RE: Bullitt Central High School (25-145)
Change Order 5—Water main conflict

Change Order

CHANGE ORDER INFORMATION:
Change Order Number: 005

RFI #6: Water Main and Storm Conflict

[Bullitt Central Physical Science Building RFI 6.pdf](#)

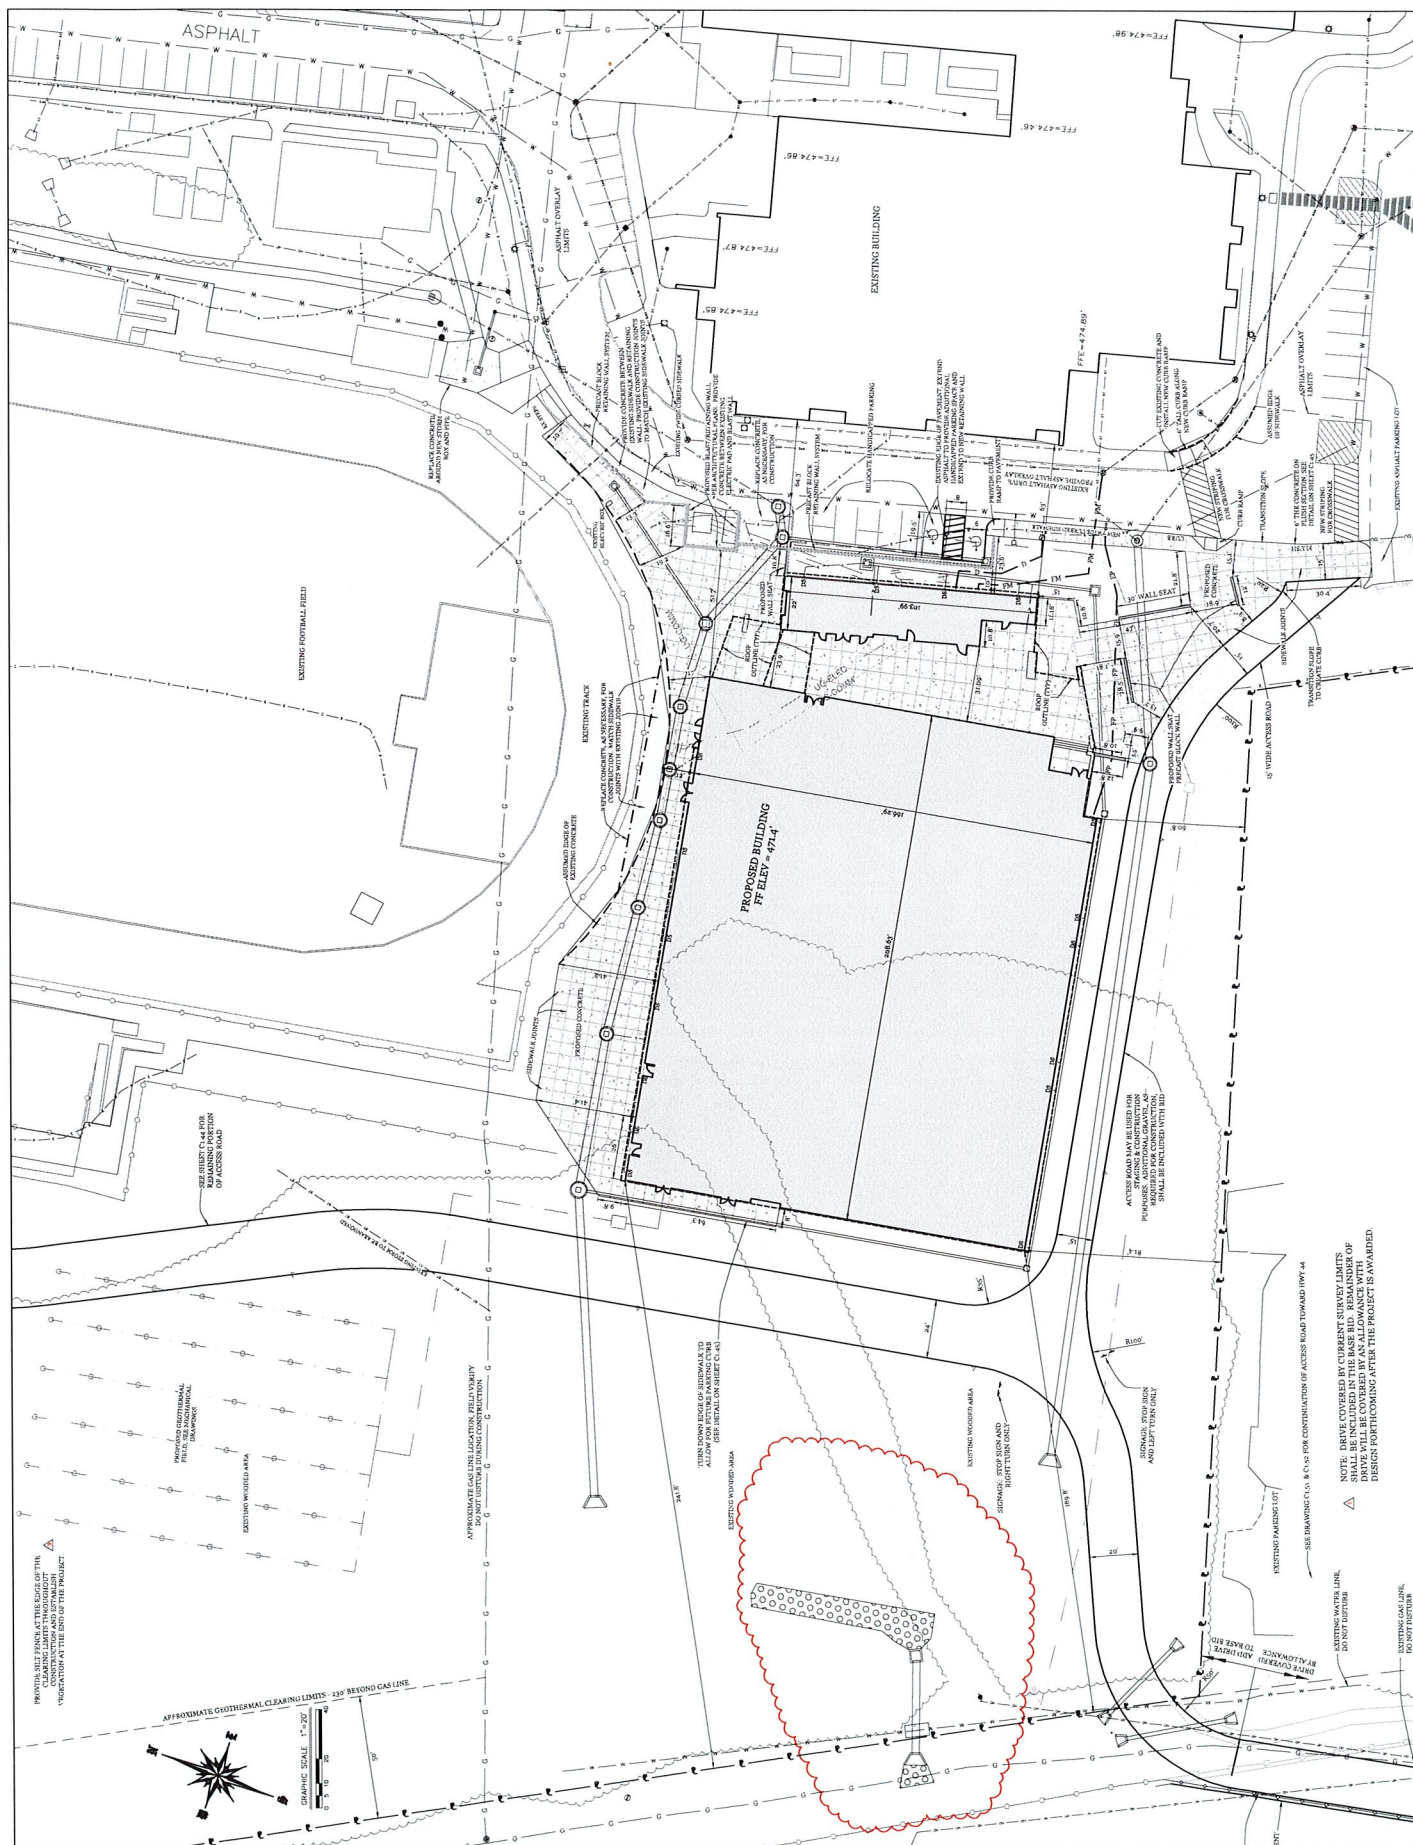
While preparing to install the 36" storm pipe associated with HW3 and OS1, we found an existing 18" watermain in the same alignment.
The top of the existing 18" water main stands at 461.438'.
The invert elevation for the 36" storm is 460.2'
See attached for visual.
Please advise how to proceed.

See attached for revision to move the outlet structure and regrade the bottom of the detention basin. A concrete cap shall be added between the existing water main and the proposed storm pipe. Rip-rap shall be added at the bottom of the detention basin due to reduction of slope of the basin. Thanks, Robin

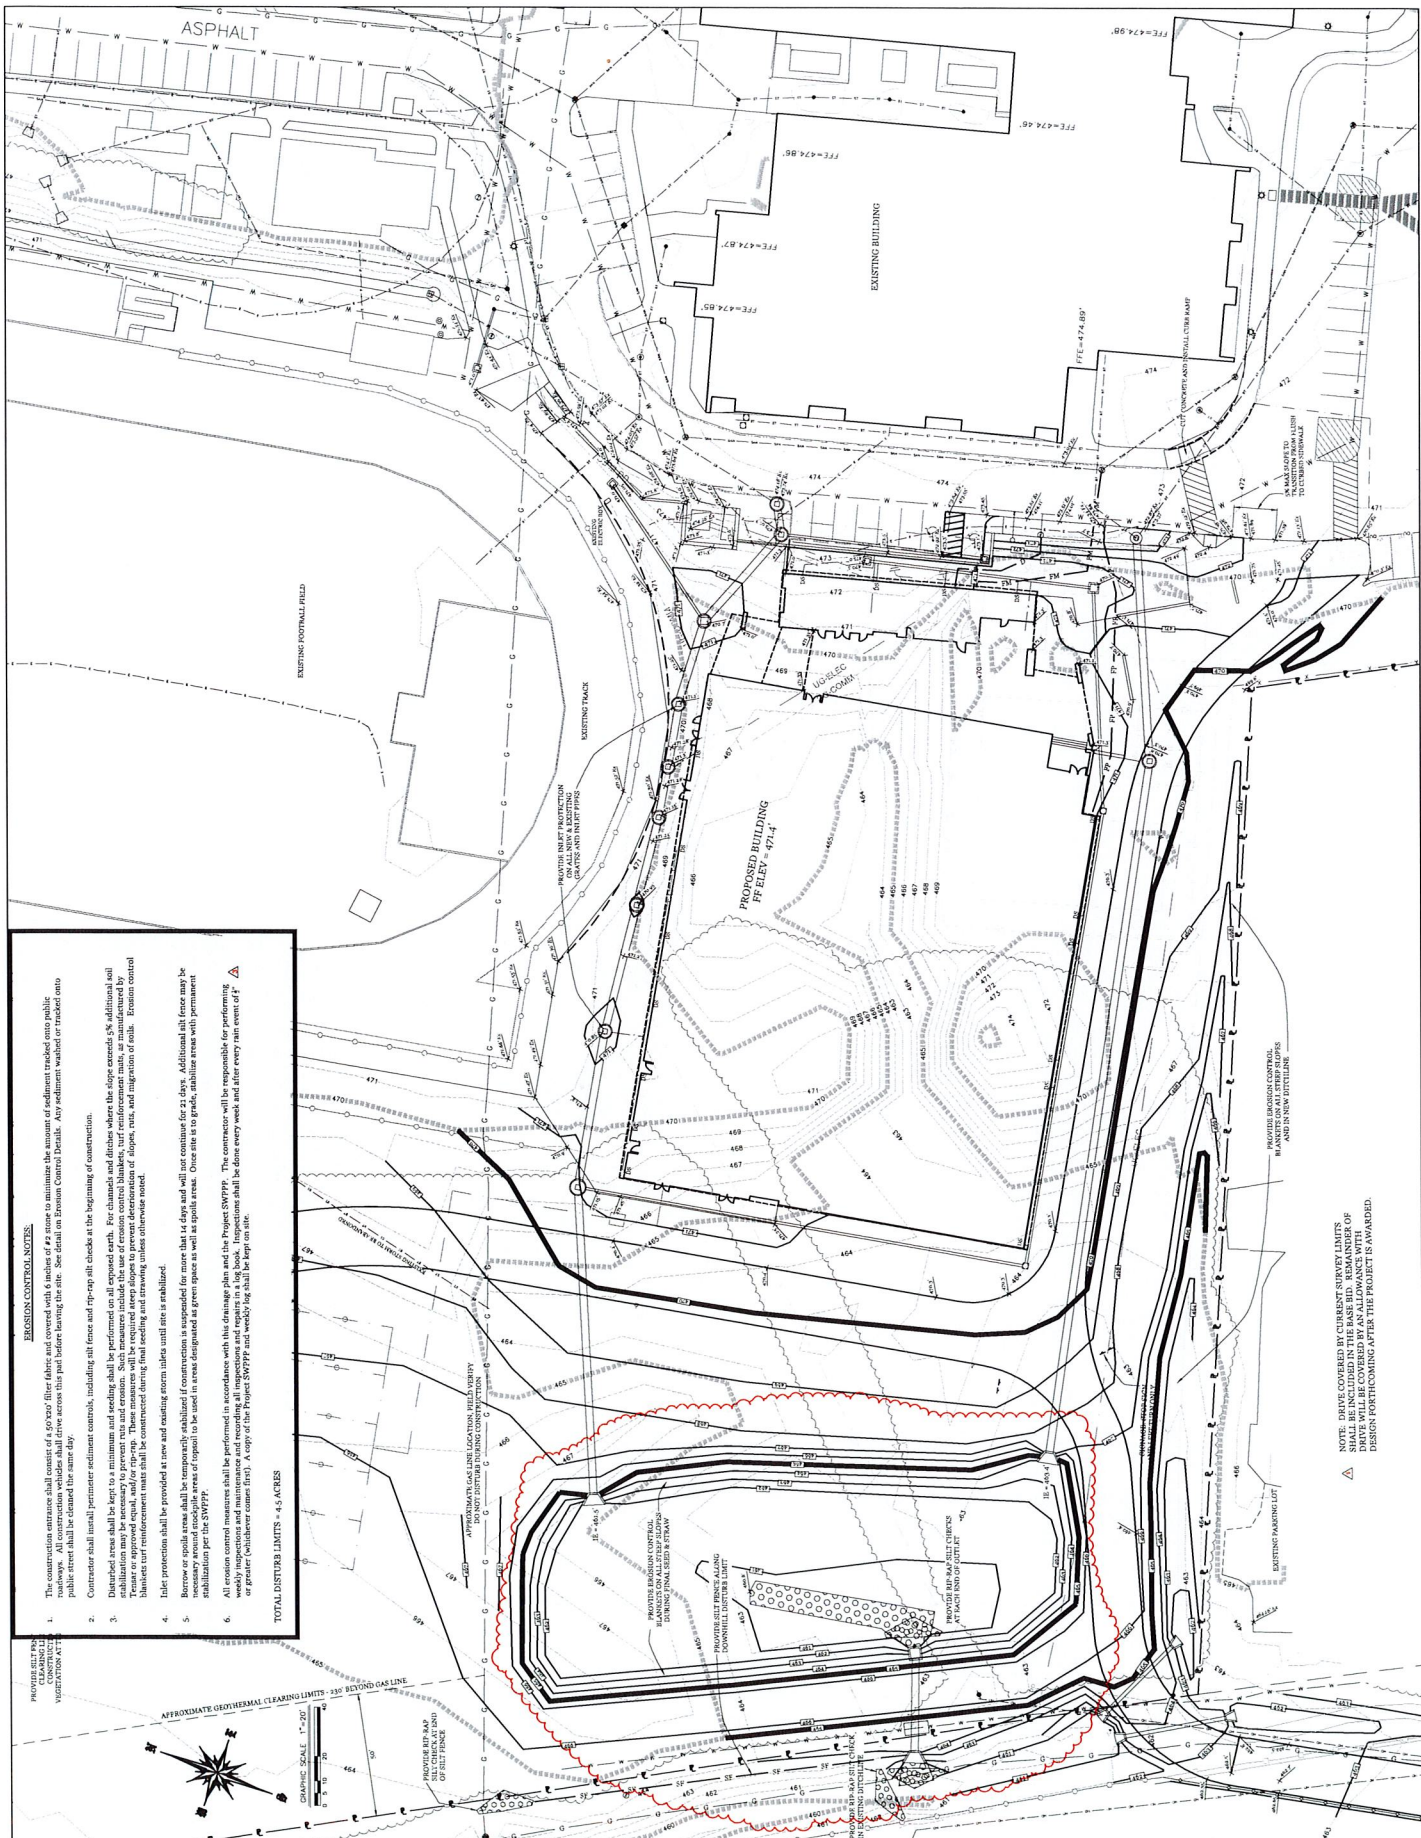
RFI 6 - cost to move location of basin outlet control structure, added rip rap and concrete cap. regrade bottom of basin to drain

See attached for revision to move the outlet structure and regrade the bottom of the detention basin. A concrete cap shall be added between the existing water main and the proposed storm pipe. Rip-rap shall be added at the bottom of the detention basin due to reduction of slope of the basin. Thanks, Robin
